# Appendix K - Santos Fairview Water Release Scheme

Preliminary Document Public Comment Responses

18-Jul-2023  
EPBC 2021/8914 - Fairview Water Release Scheme

**Figure 5 – Flow duration curve for Dawson River (Wardinggarri) at Utopia Downs, with daily treated water release rate indicated (orange line). The release rate exceeds natural river discharge monitored at this point approximately 40% of the time.**

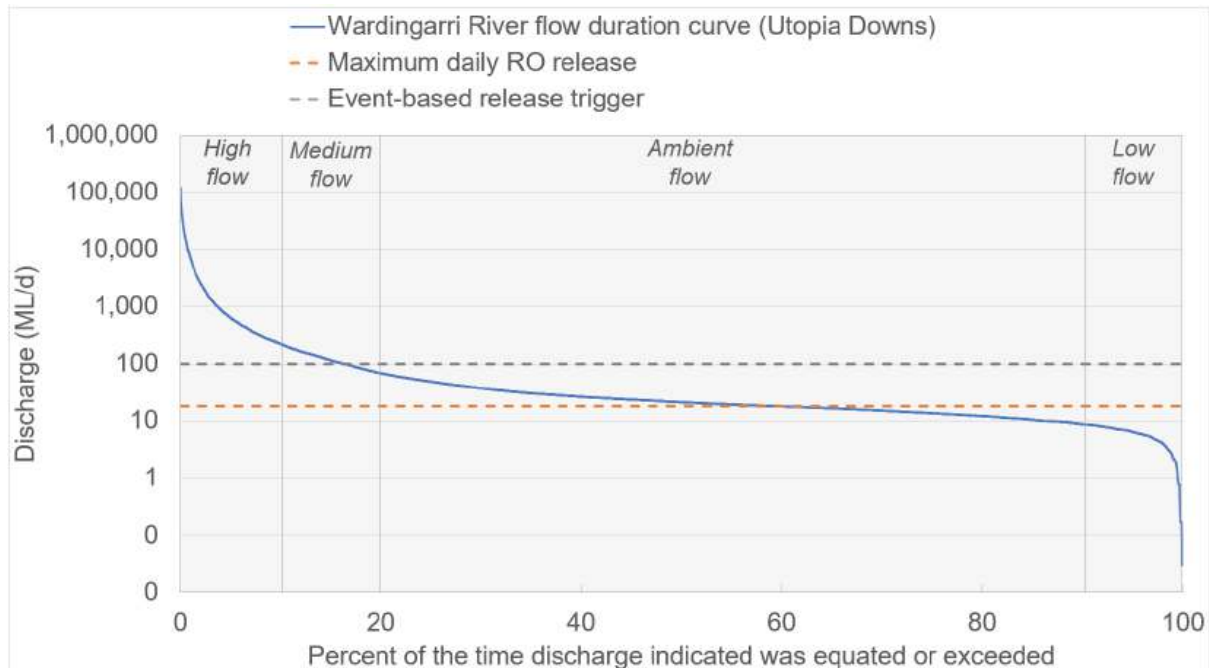
Daily discharge of 18 ML/day will significantly reduce the magnitude and duration of low-flow spells in the Dawson River – Figure 5 shows a comparison of this discharge rate with the flow duration curve for Utopia Downs, approximately 60 km downstream of the releases.

**Figure 6 – Number of low flow days per year in Dawson River (at Utopia Downs) with and without daily treated releases, based on historical flows data (Nicholson et al., 2022).**

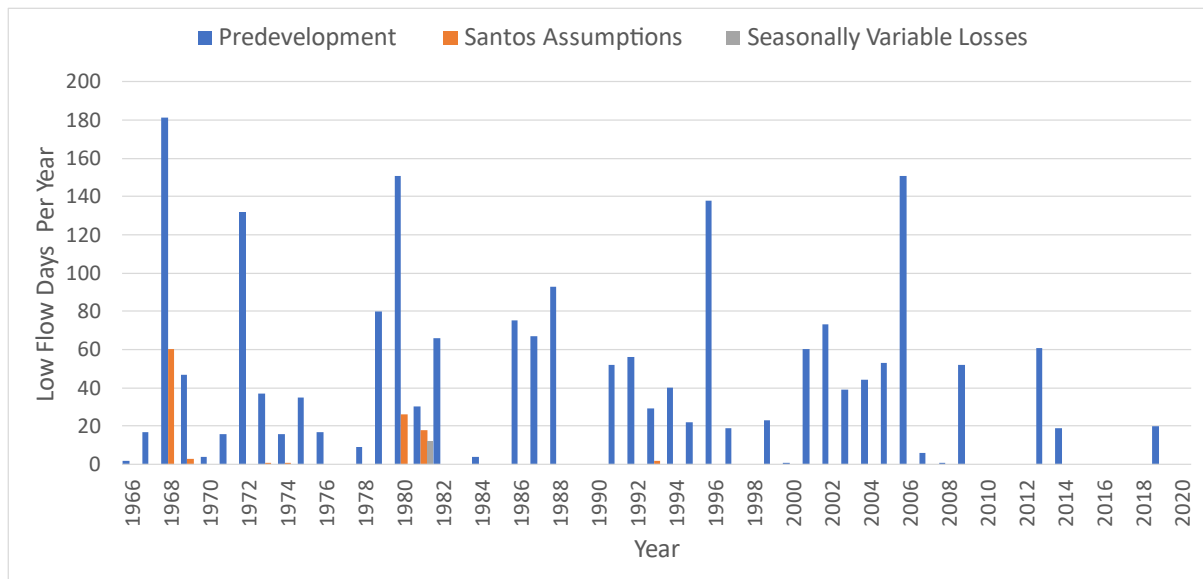
The river flow data across back to 1966 were analysed under these three scenarios, with additional flows from the treated releases added to historically recorded flows. The most notable change in any HRV under the proposed discharge scenarios is the significant decline in number of low flow days (LFDs). While some low flow days still occur under the two discharge scenarios, these were largely during historic droughts (1968 and 1979-1982) with minimal occurrence throughout the rest of the record.

**Figure 6 – Hydrograph of Evergreen Formation; a) bore location with respect to oxbow lake and Dawson River, b) groundwater level (m AHD) over time. Data from Queensland Globe**

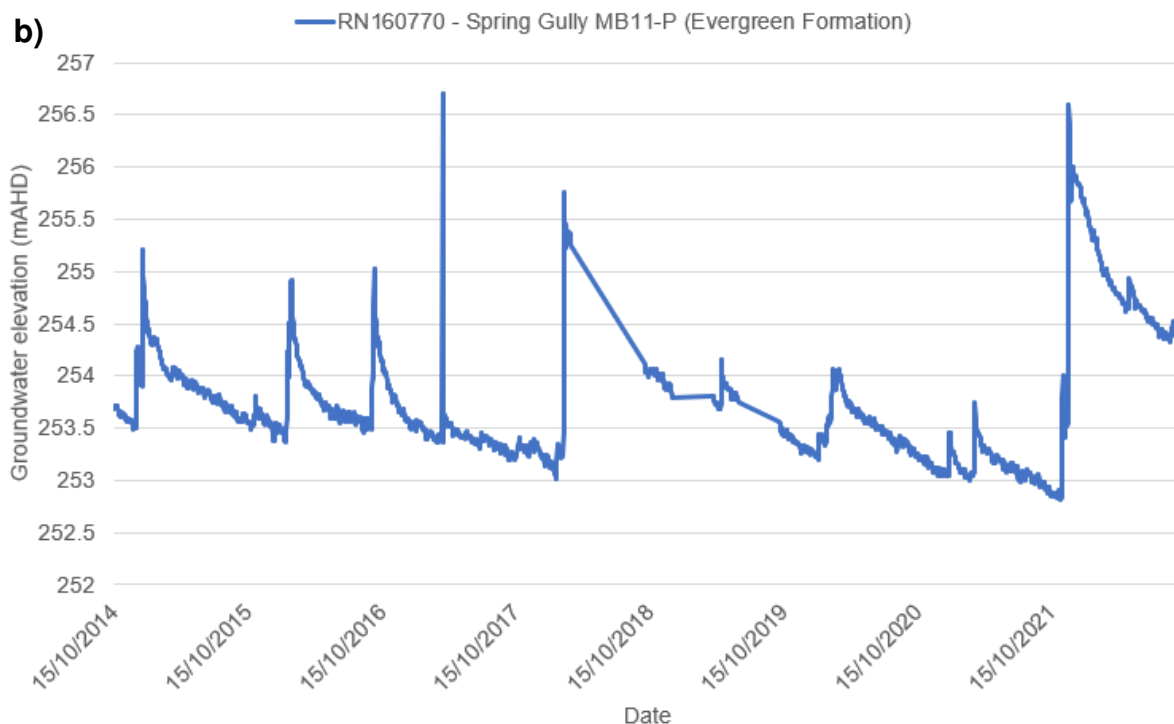
Data from bore RN160770, screened in the upper Evergreen Formation near the Dawson River, shows rapid, periodic increases in level that decline gradually between rainfall events.

The bore is screened from 16 to 79 m below ground surface across the Evergreen Formation. Water level is approximately 35 to 40 m below ground surface level; noting that the bore is located at the top of a steep cliff adjacent to the Dawson River channel – elevation at the river channel is approximately 250 m AHD (i.e., similar to the groundwater levels recorded in the bore). The periodic rises and subsequent fall in groundwater level imply that the aquifer has substantial permeability and is recharged rapidly, potentially through pulses of flow from the nearby alluvial channel of the Dawson River when it floods. The groundwater in the bore has a field EC value (last measured in 2014) of 200  $\mu\text{S}/\text{cm}$ , consistent with this interpretation and indicating fresh groundwater with minimal solute concentration during recharge (as would be expected for groundwater in an aquitard). As such, a connection between the Dawson and/or its nearby alluvial sediments, and groundwater in the upper Evergreen Formation should be considered a potential key aspect of the conceptual hydrogeological model.
